September 10, 2010

**Re: Construction Storm Water Inspection at OSU Medical Center Improvements
(Medium Voltage Part 1) and OSU Medical Center Improvements
Franklin County
Permit Number: 4GC03171*AG & 4GC03058*AG**

Figure 1: Sediments seen running off into the storm drain.

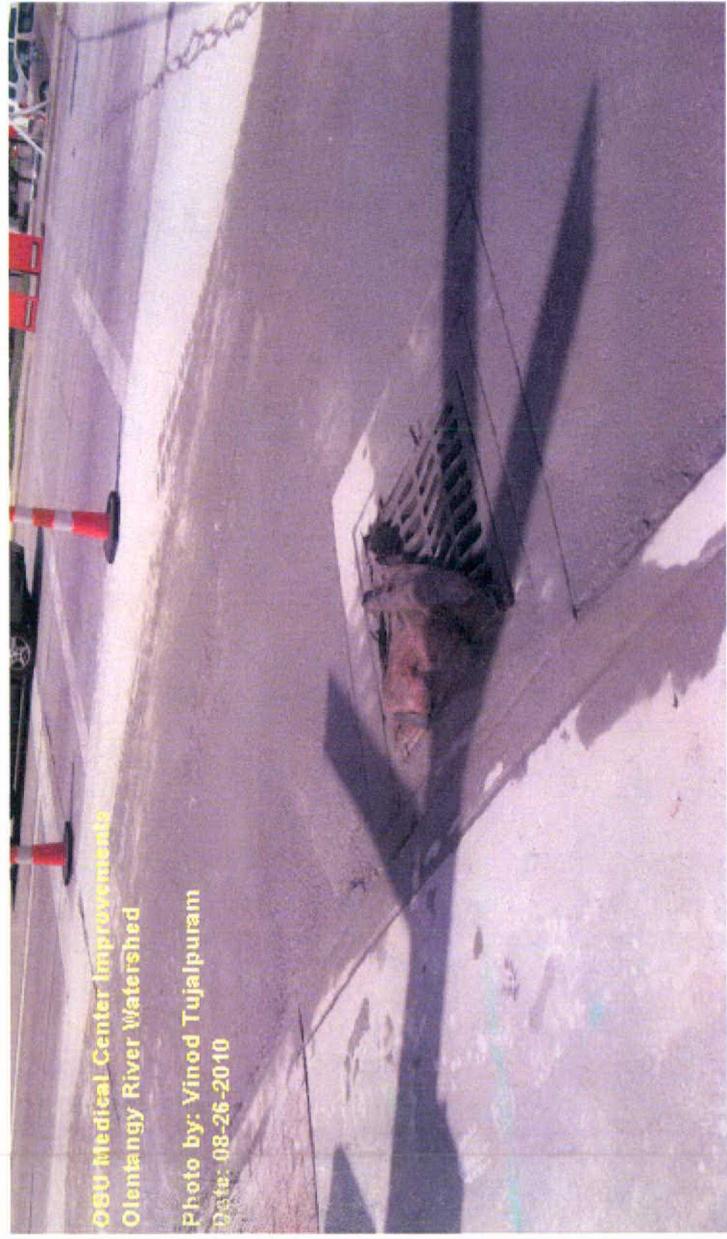
- The storm drain located in front of the Medical Center Building on W 10th Avenue has been damaged and will require maintenance at this time. Corrective measures are expected within three days from receipt of this letter.
- There is evidence that the water from dewatering activities was discharged into the storm drains located on site at the intersection of West 12th Avenue and Cannon Drive (See Photos). Please ensure the dewatering from the impoundments do not result in turbid disturbances to the waters of the state.
